Well Name: CORRAL 23-35 FED COM	Well Location: T25S / R29E / SEC 23 / SENW / 32.118164 / -103.957998	County or Parish/State: EDDY / NM
Well Number: 209H	Type of Well: OIL WELL	Allottee or Tribe Name:
Lease Number: NMNM120895	Unit or CA Name:	Unit or CA Number:
US Well Number: 3001556887	Operator: XTO ENERGY INCORPORATED

Notice of Intent

Type of Submission: Notice of Intent	Type of Action: APD Change
Date Sundry Submitted: 07/08/2025	Time Sundry Submitted: 02:47
Date proposed operation will begin: 07/15/2025

Procedure Description: XTO Energy Inc. respectfully requests approval to make the following changes to the approved APD. Changes include KOP, FTP, LTP, BHL, Proposed total depth, pool, and dedicated acreage, Formation, Casing Design, Cement Program & Mud Circulation System. APD ID 10400098927; Well API: 30-015-56887 FROM: TO: KOP: 1673' FNL & 1771' FWL OF SECTION 23-T25S-R29E 330' FNL & 1370' FWL OF SECTION 23-T25S-R29E FTP: 100' FNL & 1380' FWL OF SECTION 23-T25S-R29E 330' FNL & 1370' FWL OF SECTION 23-T25S-R29E LTP: 100' FSL & 1380' FWL OF SECTION 26-T25S-R29E 330' FSL & 1370' FWL OF SECTION 35-T25S-R29E BHL: 50' FSL & 1380' FWL OF SECTION 26-T25S-R29E 50' FSL & 1370' FWL O

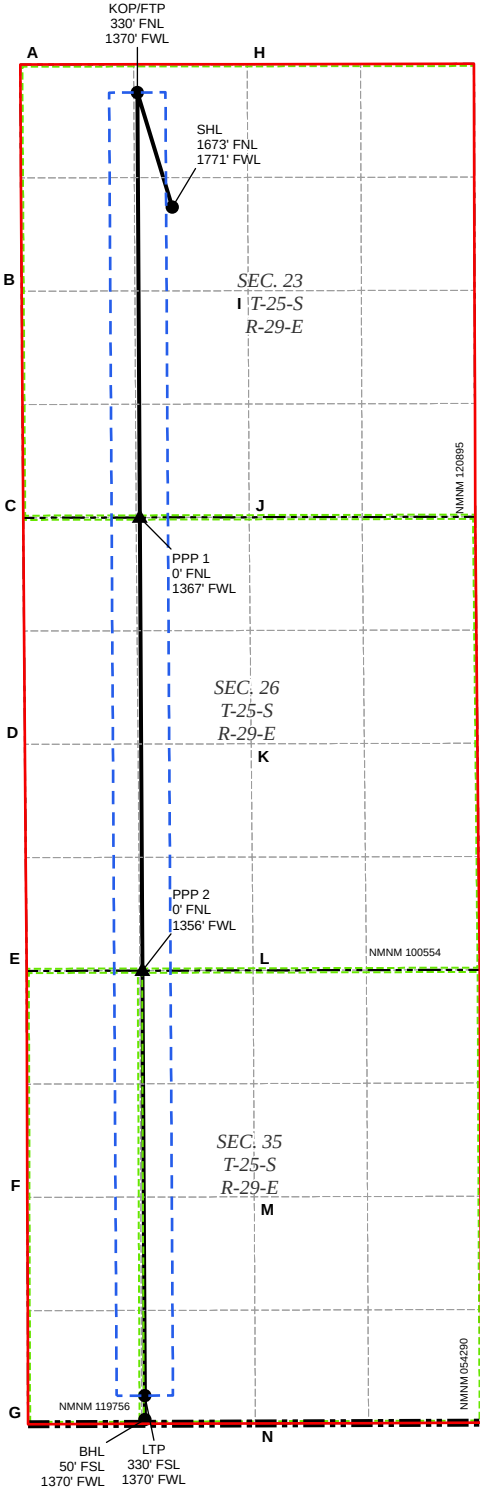
UL	Section	Township	Range	Lot	Ft. from N/S	Ft. from E/W	Latitude	Longitude	County
N	35	25S	29E		330 FSL	1,370 FWL	32.079879	-103.959192	EDDY

OFFLINE CEMENTING

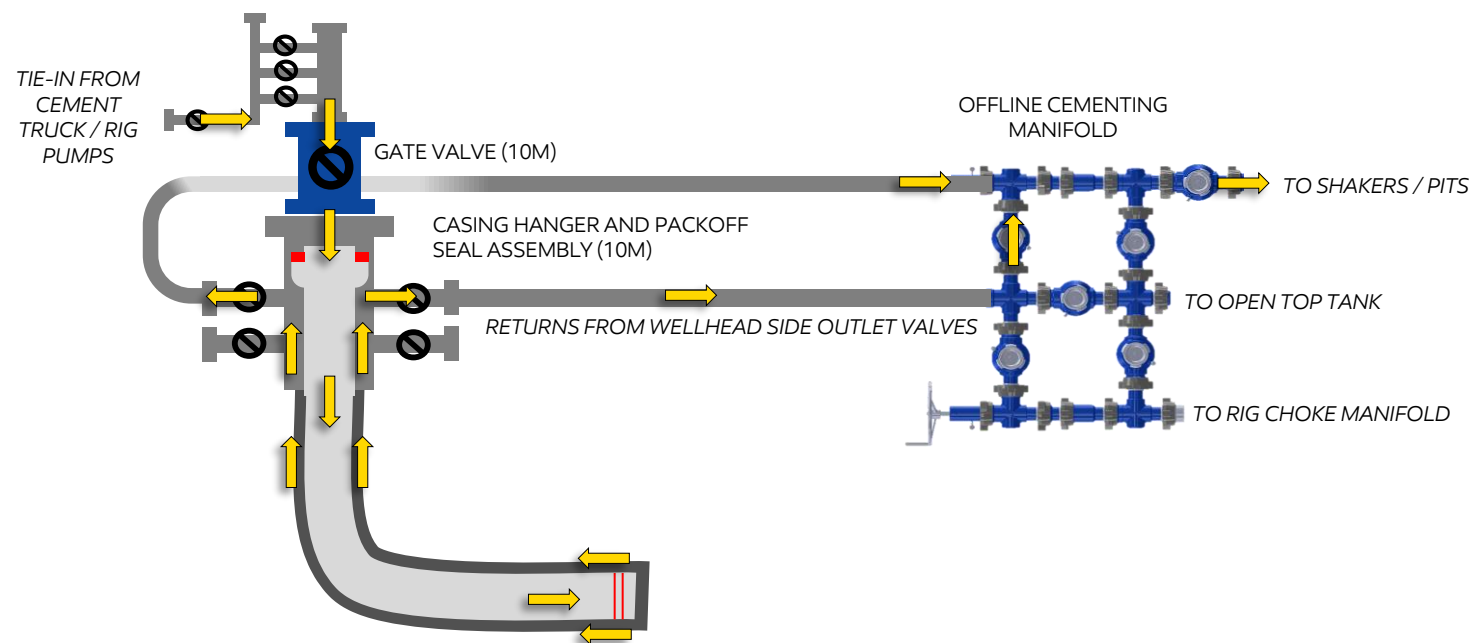
KEY DIFFERENCES

1. Rig BOP replaced by gate valve and WH adaptor assembly (10M rated)
2. Addition of offline cementing manifold and high pressure iron to direct fluid returns to rig active system and/or choke manifold
3. Packoff annulus barrier in place and tested prior to cementing operations (10M rated)
4. Cement truck performs cement job displacement (vs rig pumps)
